Access Compliance Report

Public Rights-of-Way

(Curb Ramps)

Intersection ID: 27595	Main Street: BALLANTYNE COMMONS PY	Cross Street: BALLANTYNE MEADOWS DR	Location: SE
ADA ID: 2E1E1A5B207F	Ramp Type: BlendTrans2	Initial Pass/Fail: Fail	Overall Compliance: No
		Severity Score: 10

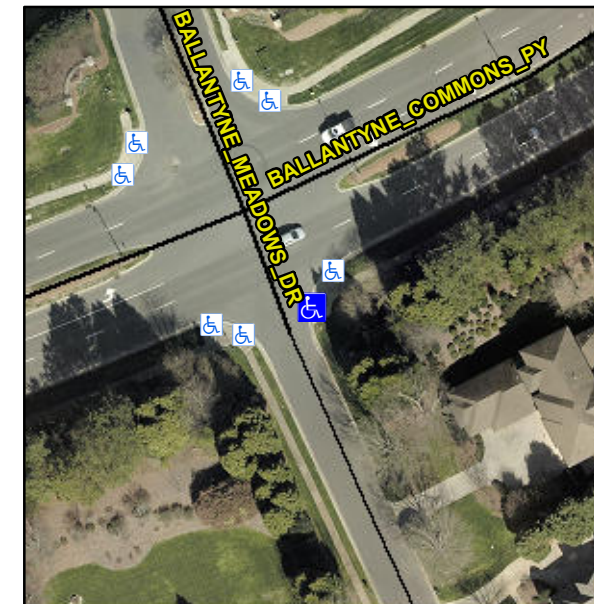
R304.5.1, R304.5.3

Compliance	Description	Data	Compliance	Description	Data
N/A	Ramp Length (in)	116.0	Yes	BlendTrans Slope (%)	2.8
No	Ramp Width (in)	44.0	No	BlendTrans XSlope (%)	3.7
N/A	Flare Type LT	N/A	N/A	Flare Type RT	N/A
N/A	Flare Slope LT (%)	N/A	N/A	Flare Slope RT (%)	N/A
N/A	Flare Traversable LT?	N/A	N/A	Flare Traversable RT?	N/A
N/A	Landing Length (in)	N/A	N/A	DWS Provided?	N/A
N/A	Landing Width (in)	N/A	N/A	DWS Contrast?	N/A
N/A	Landing Slope (%)	N/A	N/A	DWS Length (in)	N/A
N/A	Landing X Slope (%)	N/A	N/A	DWS Full Width?	N/A
N/A	Landing Curb? (Y/N)	N/A	N/A	DWS Offset (in)	N/A
N/A	Shared Landing?	N/A			
N/A	Gutter Ponding?	N/A	N/A	Gutter Slope (%)	N/A
N/A	Gutter Lip Ht (in)	N/A	N/A	Gutter X Slope (%)	N/A
N/A	Painted X Walk1?	No	N/A	Painted X Walk2?	N/A
	X Walk 1 Direction	To SW		X Walk 2 Direction	N/A
	X Walk 1 Width (in)	N/A		X Walk 2 Width (in)	N/A
	X Walk 1 Slope (%)	1.0		X Walk 2 Slope (%)	N/A
	X Walk 1 X Slope (%)	2.9		X Walk 2 X Slope (%)	N/A

Remove & Replace Curb Ramp With Two New Directional Ramps or Equivalent.
